Firmware PowerZone® Connect - 2026.18.1

(update from 1.8.2)

- **Two additional priority input levels per zone.**

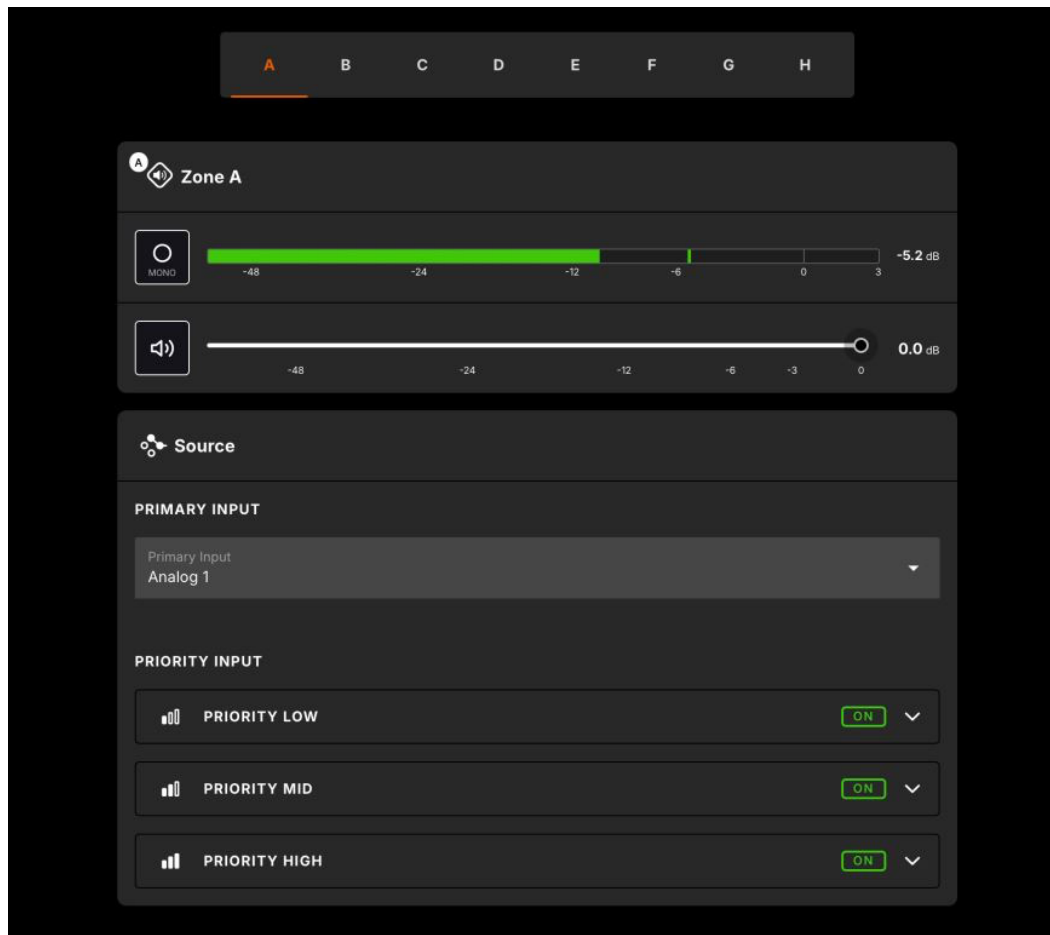
- This update adds two extra priority input levels per zone, expanding system flexibility. The new priorities include:
 - Threshold control
 - Zone volume override
 - Hold time functionality
- Example setup – retail environment:
 - Primary input: Background music
 - Priority Low (overrides primary input): Commercials
 - Priority Mid (overrides primary and low input): Microphone announcements
 - Priority High (overrides all): Voice alarms

- **Dark mode is now the default appearance setting.**

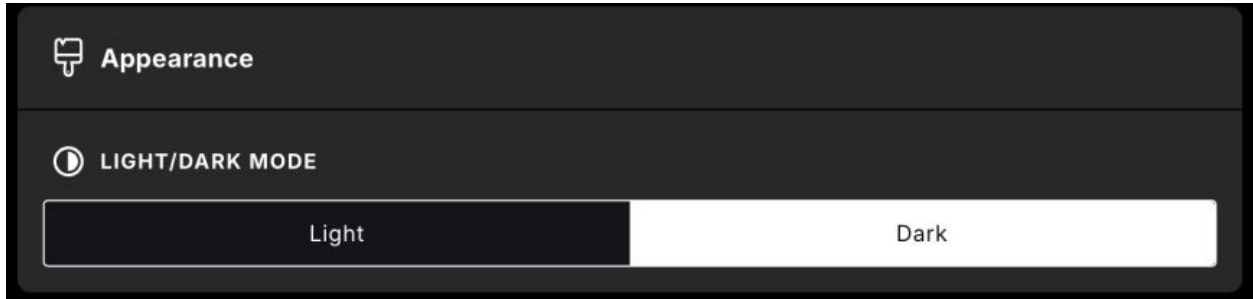
- A new “Appearance” tab under Settings lets users switch between Light and Dark mode. This setting applies only to the selected amplifier and does not affect the PowerZone™ Control Center interface

Features

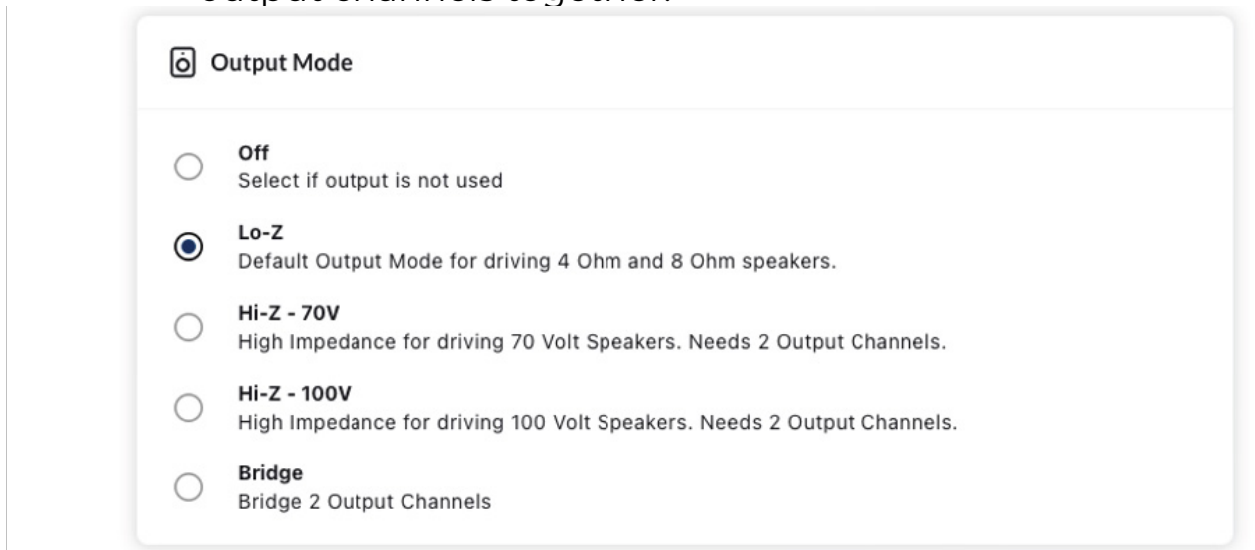
- Enabling BTL mode / Bridge mode on 1U units.
 - This has always been enabled for 2U units, but it is now enabled on 1U units as well, so the installer can bridge two output channels together.

Area 1 – Button arrangement (EQ)

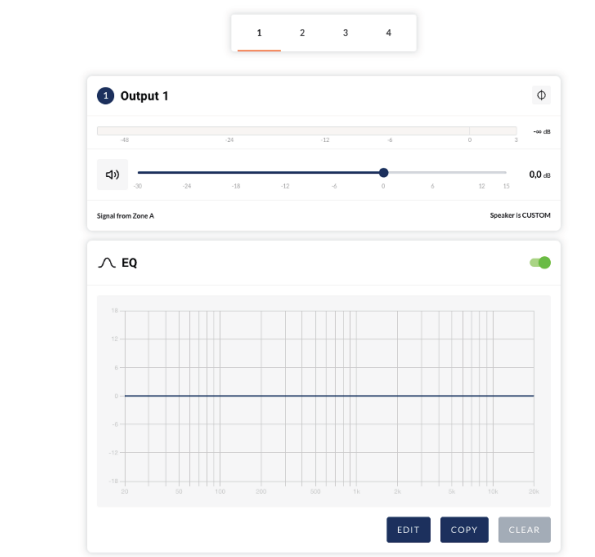
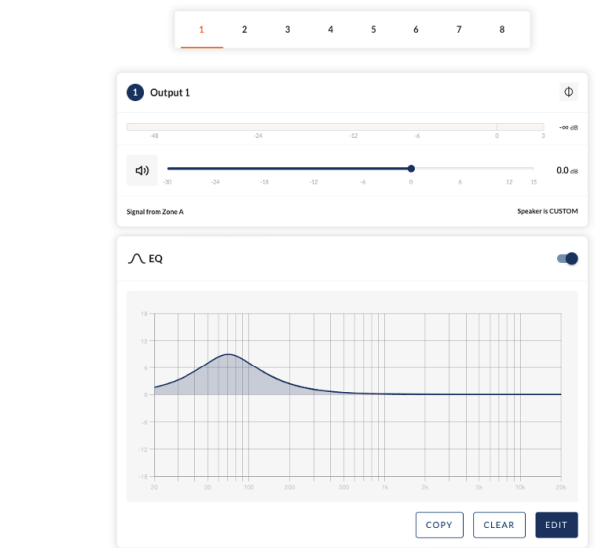
Primary buttons are placed towards the right, while the secondary buttons from left to right.

Area 4 – Secondary buttons e.g., “Reset” is outlined

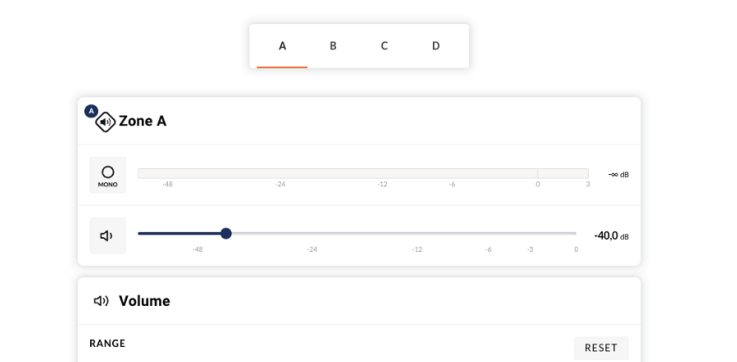
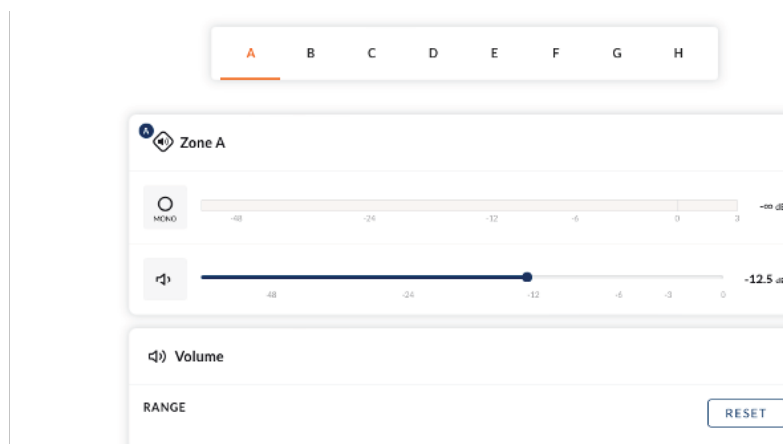
This goes throughout the entire GUI, so all secondary buttons are marked with an outer line.
